Proposed Modification to Redisand Salt Ash Sand project approval 07_0094

March 2017

Redisand Pty Ltd

Figure 2 – Proposed Quarry Layout

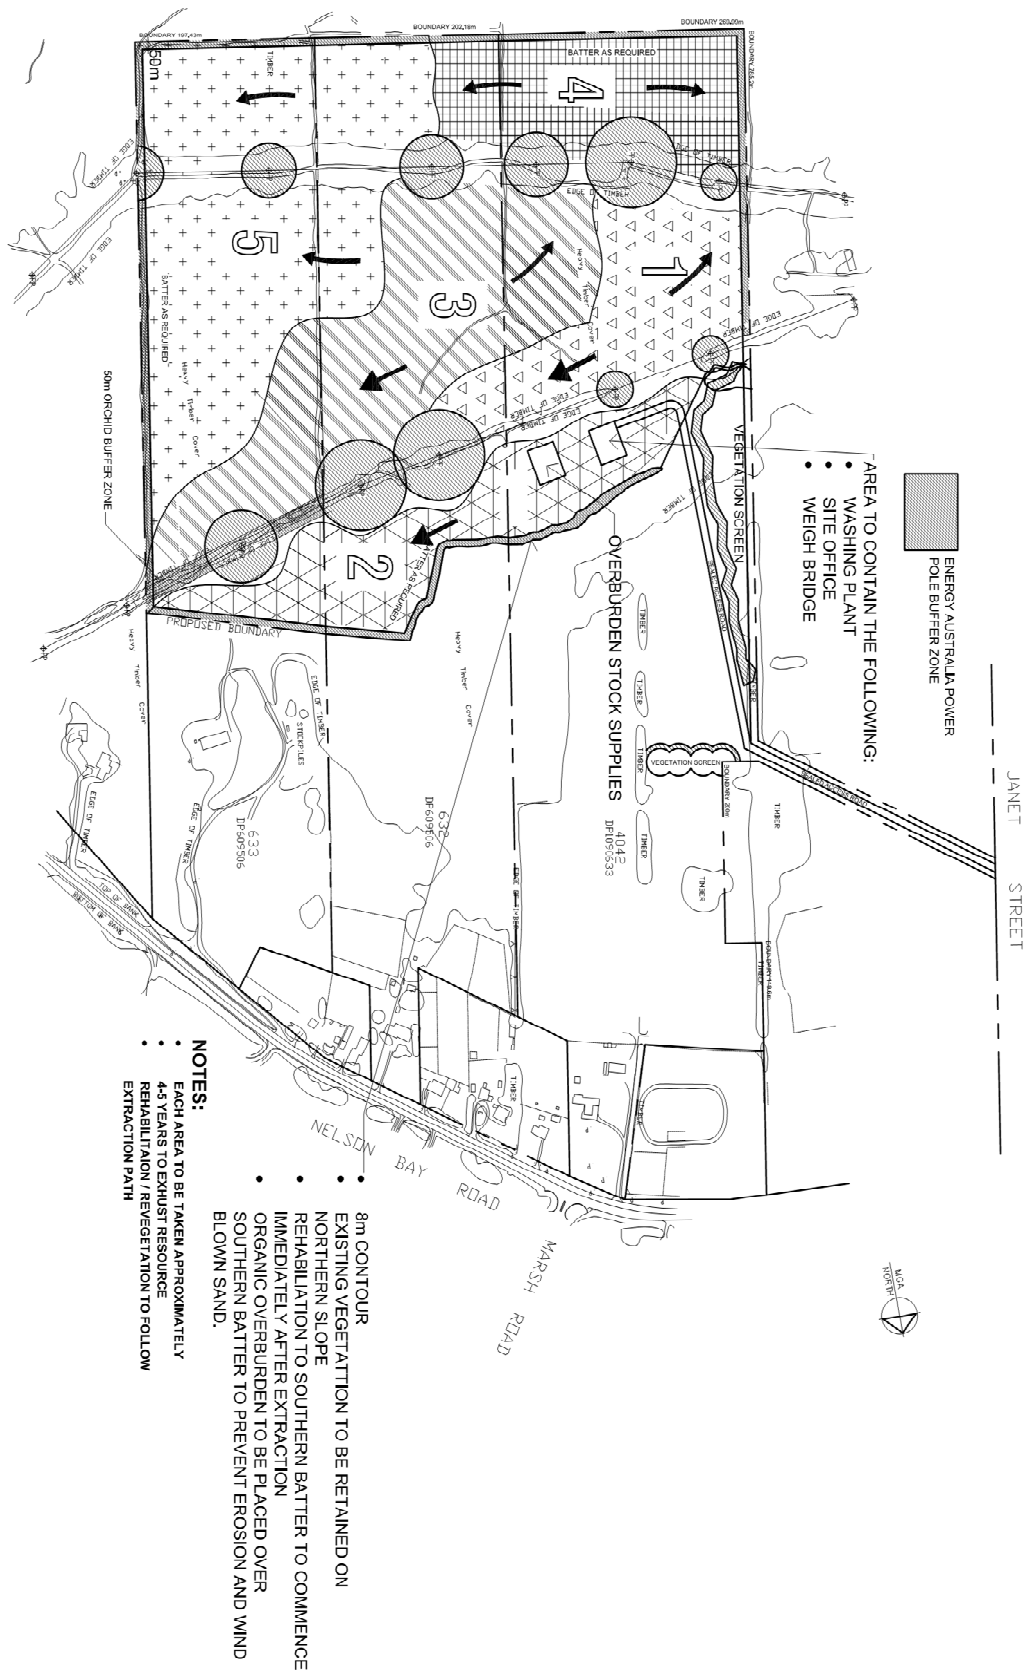
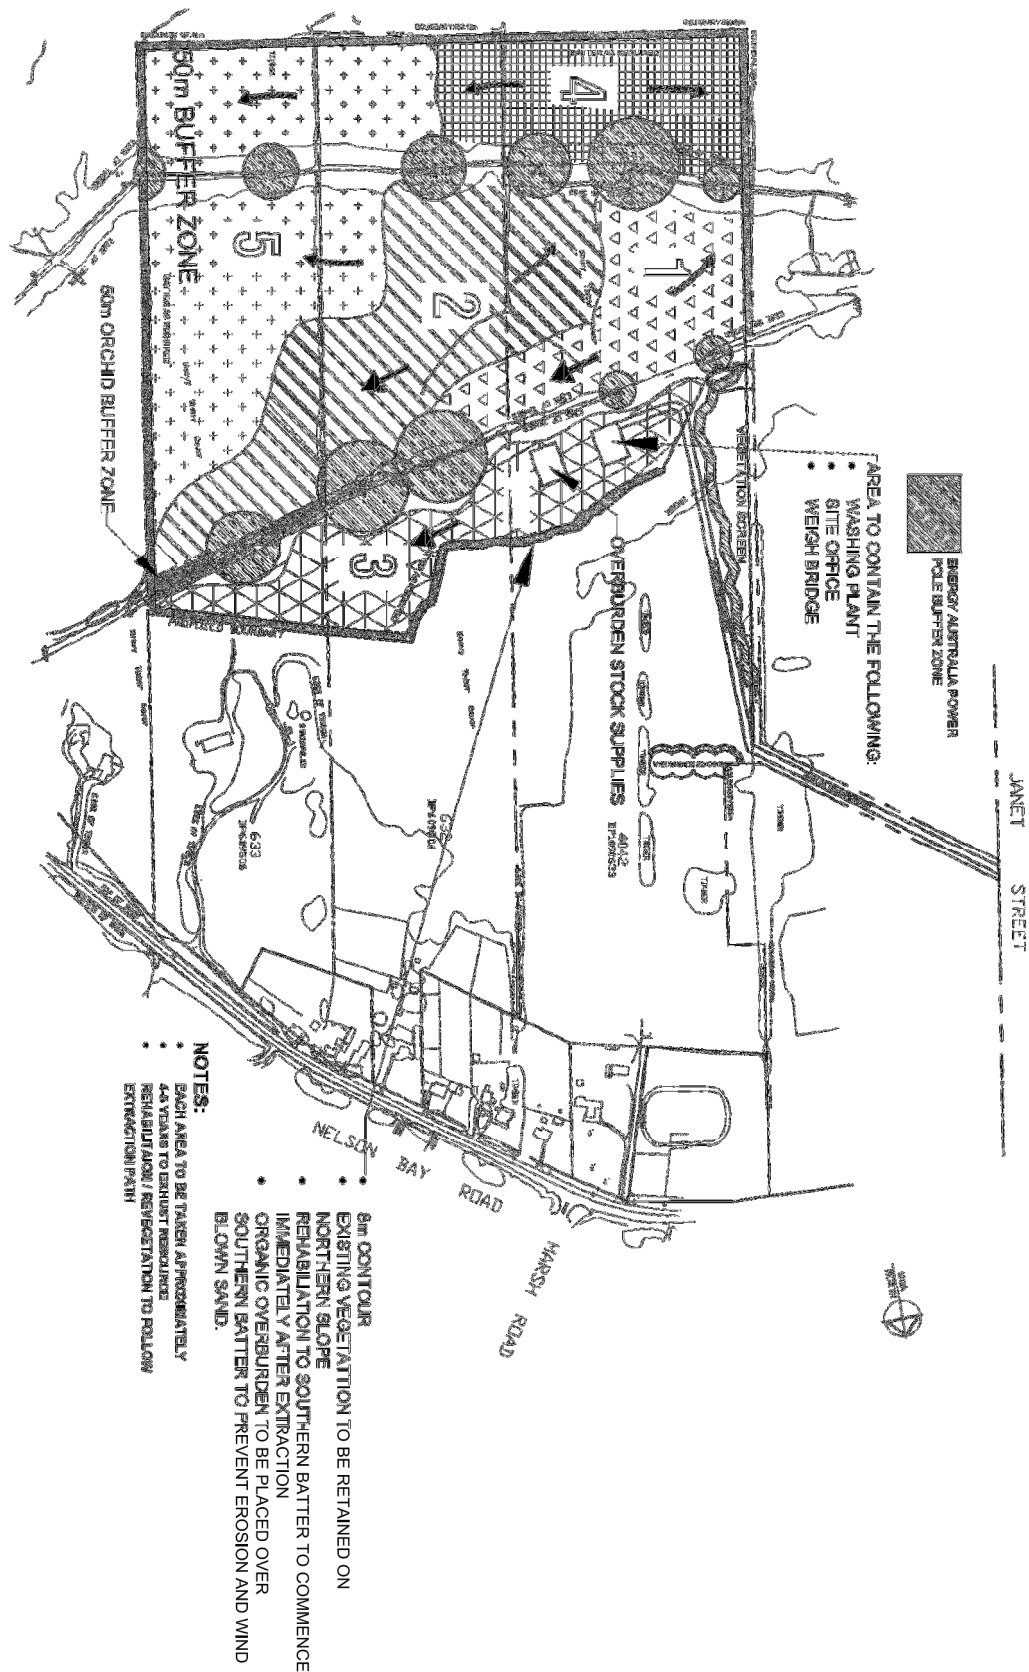
The application will also propose the modification to the approved extraction sequence. Namely, Stage 2 will become Stage 3 and Stage 3 will become Stage 2. The altering of the extraction sequence will allow for uniformed extraction and improved rehabilitation of each respective stage.
